I am writing to submit my **OBJECTION** to SSD-65595459 Hunter Indoor Sports Complex (HISC), and have highlighted the reasons below that have not been sufficiently addressed by the applicant:

Figure 1: Pictures taken during the East Coast Low (30 April 2025) showing increased water levels in Ker-rai Creek along the proposed site on Monash Road, and flooding on Turton Road, where the entrance to the proposed stadium would be.

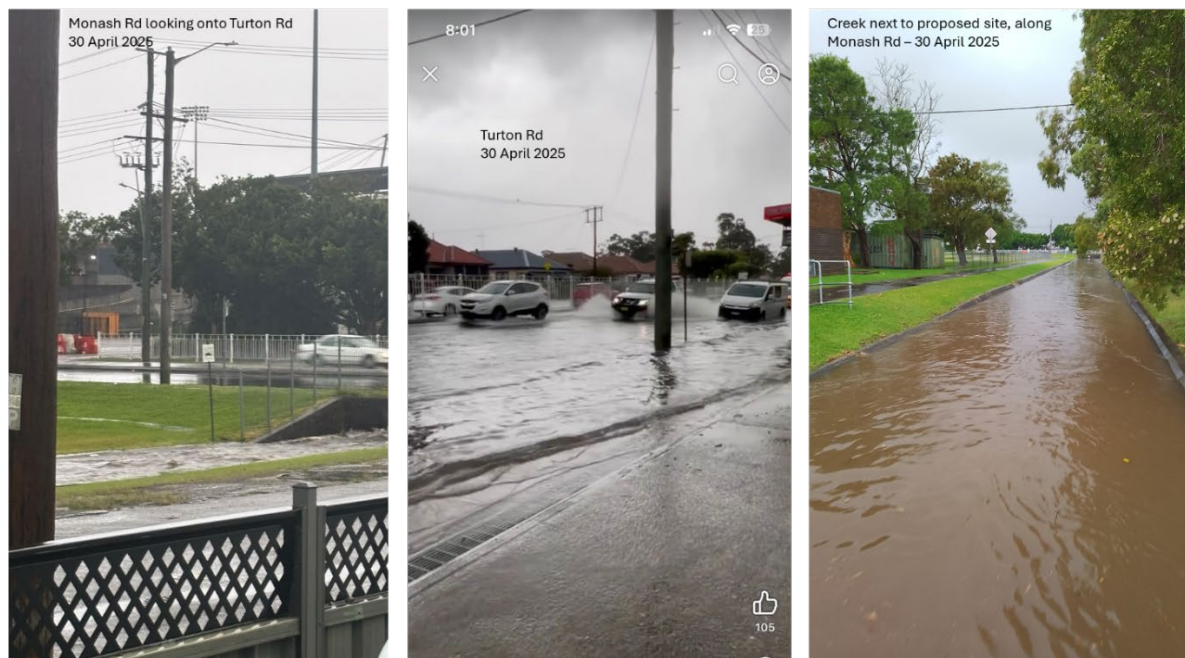
According to Appendix I – Flood Impact Risk Assessment, at the 1% AEP (2050) event, this proposed development can cause a localised increase in modelled peak flood level of 20-30 mm, mostly within the proposed site but with some extension off-site for around a 100 m length of Lambton Ker-rai Creek and Monash Road (Appendix I Section 5.3). At the PMF (Probable Maximum Flood) event, there is a modelled increase of peak flood level of 60-70 mm between

approximately the Harker and Ford Ovals to the west and Marina Avenue to the east (Appendix I Section 5.3). This exceeds the City of Newcastle ideal threshold of 50mm, and the increases are at the upper limit of acceptability.

The NSW guidelines emphasize that impacts should be assessed based on whether they result in relatively minor impacts beyond the development site or have detrimental impacts that affect other land or the community more broadly (Flood Risk Management Guideline LU01 (Section 3.2.2)). The Flood Impact Risk Assessment concludes impacts are 'minor' and 'negligible', but the off-site flood level increases of 60-70mm at PMF and velocity increases in Turton Road and Lambton High School suggest impacts extend beyond the development site. The significance of the flood impact is heightened due to the fact that these increases affect existing residential areas and critical evacuation routes, making them more impactful than increases in undeveloped areas would be. Based on the images I have attached of Turton Road, which is in front of the site of the proposed development (Figure 1), I believe it is remiss of the applicant to claim that these impacts are considered minor and have negligible change in flood risk to existing property and infrastructure (Appendix I pg 41).

Figure 2: Figure from RTS and Amendment Report, supposedly showing all the available green space around the proposed HISC site for use by the community.

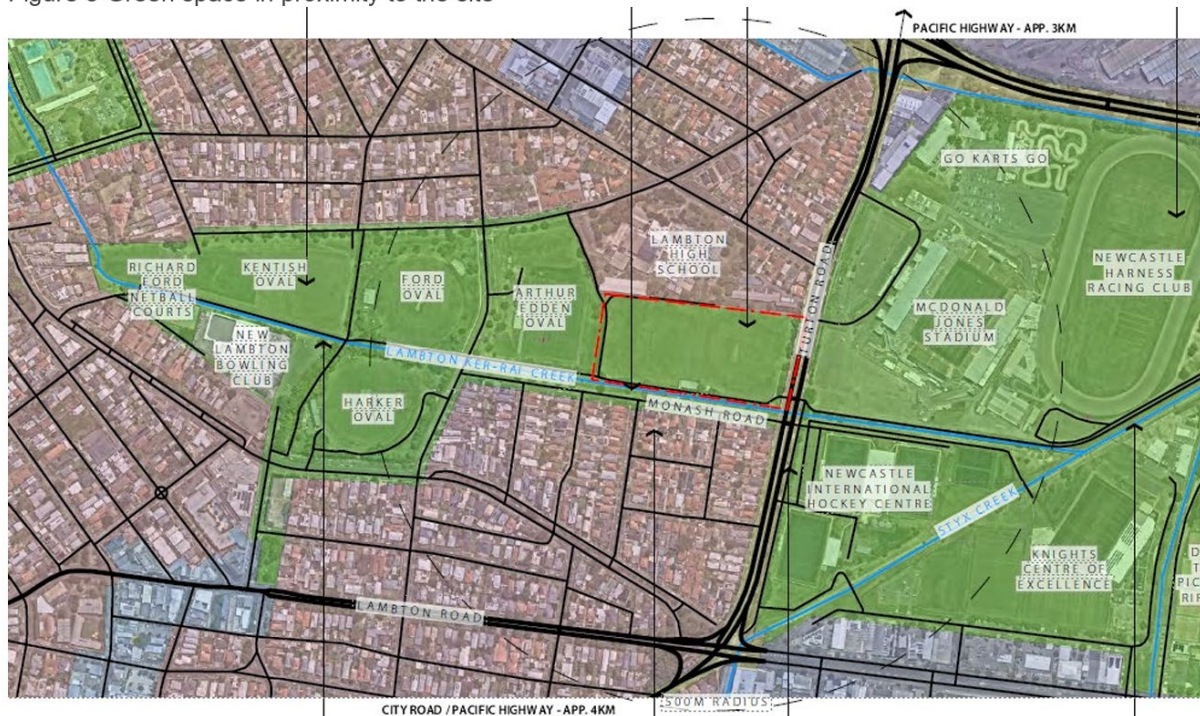
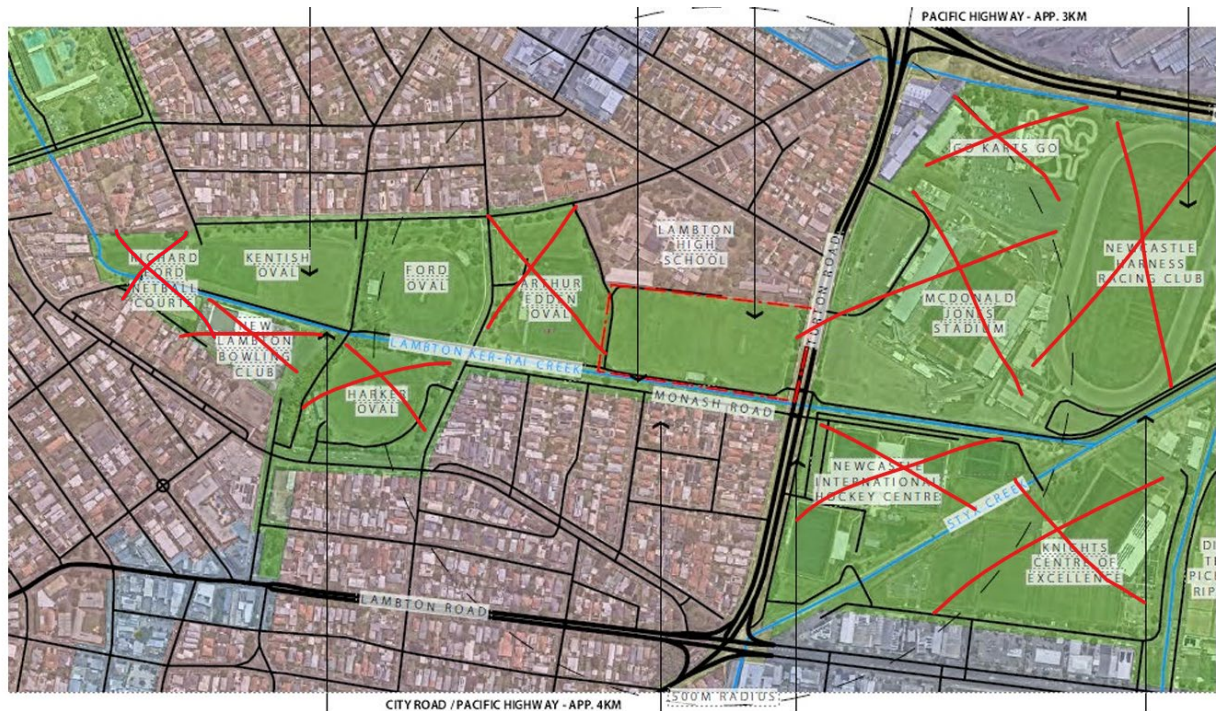
In the same report, Newcastle Basketball notes that local residents will be able to access nearby Ford Oval and Kentish Oval (and surrounds) for open space purposes, whilst Lambton High School will continue to have access to Arthur Edden and Harker Ovals, and provided Figure 8 Green space proximity to the site (Figure 2). However, I would like to highlight Figure 3, which shows the actual green space remaining for recreational and unstructured outdoor activities, and cross out the 'green space' purported by Newcastle Basketball to be accessible to the community – New Lambton Bowling Club (requires membership and only for lawn bowling), Harker Oval (District level facility, locked and not for public recreation), Arthur Edden Oval (District level facility, locked and not for public recreation), McDonald Jones Stadium (NRL, A-League and major events stadium, definitely NOT for public recreation), Knight Centre of Excellence (owned by Newcastle Knights and used as a training facility, definitely NOT for public recreation), Newcastle International Hockey Centre (premier hockey venue, definitely NOT for public recreation), Newcastle Harness Racing Club (used for touch footy and harness racing, possibly used by the community), and Go Karts Go (go-kart racing track, not green space, and definitely NOT for public recreation).

Figure 3: ACTUAL green space left for the community, with all non-accessible ‘green space’ crossed out. Note the distance between Lambton High School and Ford/Kentish Ovals, which will have to be the school’s evacuation zone if the proposed HISC proceeds. The crossed out ‘green space’ purported by Newcastle Basketball are: New Lambton Bowling Club (requires membership and only for lawn bowling), Harker Oval (District level facility, locked and not for public recreation), Arthur Edden Oval (District level facility, locked and not for public recreation), McDonald Jones Stadium (NRL, A-League and major events stadium, definitely NOT for public recreation), Knight Centre of Excellence (owned by Newcastle Knights and used as a training facility, definitely NOT for public recreation), Newcastle International Hockey Centre (premier hockey venue, definitely NOT for public recreation), Newcastle Harness Racing Club (used for touch footy and harness racing, possibly used by the community), and Go Karts Go (go-kart racing track, not green space, and definitely NOT for public recreation).
